SERVICE BULLETIN

No. 635

Piper Aircraft Corporation

Subject: Landing Gear Selector Lever Inspection and Replacement

FIGURE 1

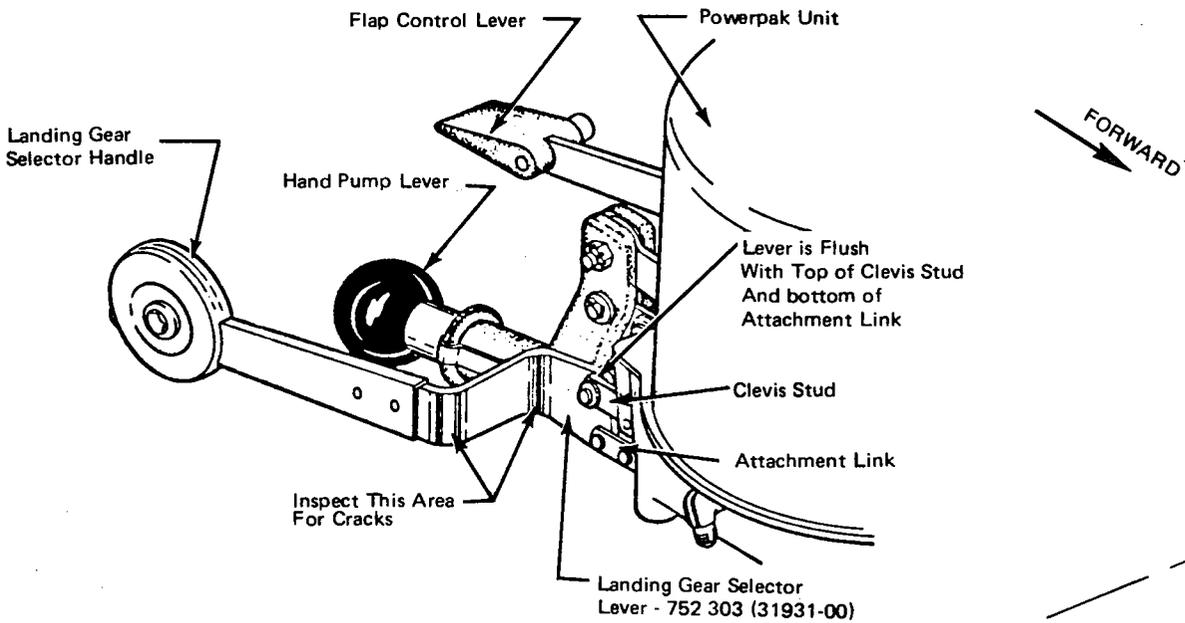
Field reports have been received of several instances of landing gear selector handles breaking off as a result of cracks developing at the bend radii of the Gear Selector Lever, Piper Part Number 752 303.

4. If the landing gear selector lever installed is Part No. 752 303 (31931-00), as shown in Figure 1, proceed to step 4a.
 - a. Inspect the two bend radii (See Figure 1) for evidence of cracks, using a 10X magnifying glass.

- b. If no cracks are found, the landing gear selector lever must be inspected at each 100 hours of operation unless landing gear selector lever Part No. 761 213 (28468-02) is installed.

- c. If cracks are found, replace existing landing gear selector lever with new heavy duty lever Part No. 761 213 (28468-02) as shown in Figure 2.
5. Reinstall rectangular access plate on right side of pedestal.

FIGURE 2

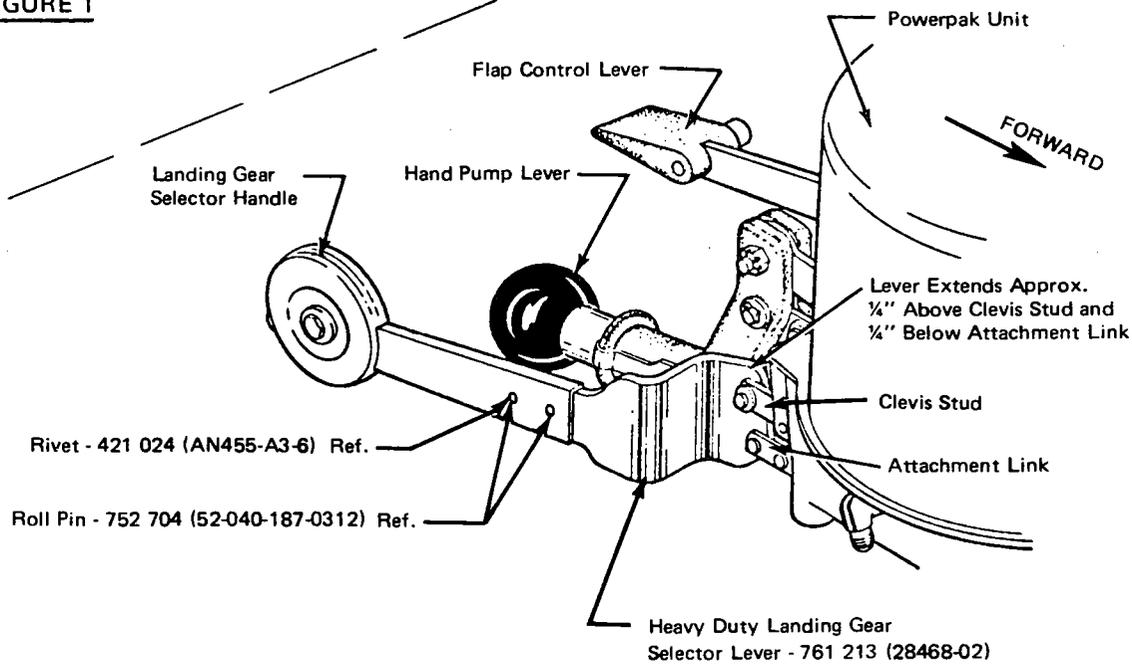
A new improved landing gear selector lever, Piper Part Number 761 213 is available as a replacement. This part is already in use on some of the above listed affected aircraft. If Piper Part Number 761 213 is found to be installed or is installed as a replacement, the one hundred (100) hour recurrent inspection requirement is relieved.

3. If the heavy duty landing gear selector lever Part No. 761 213 (28468-02) is installed, as shown in Figure 2, no further action is required. Proceed to step 5.
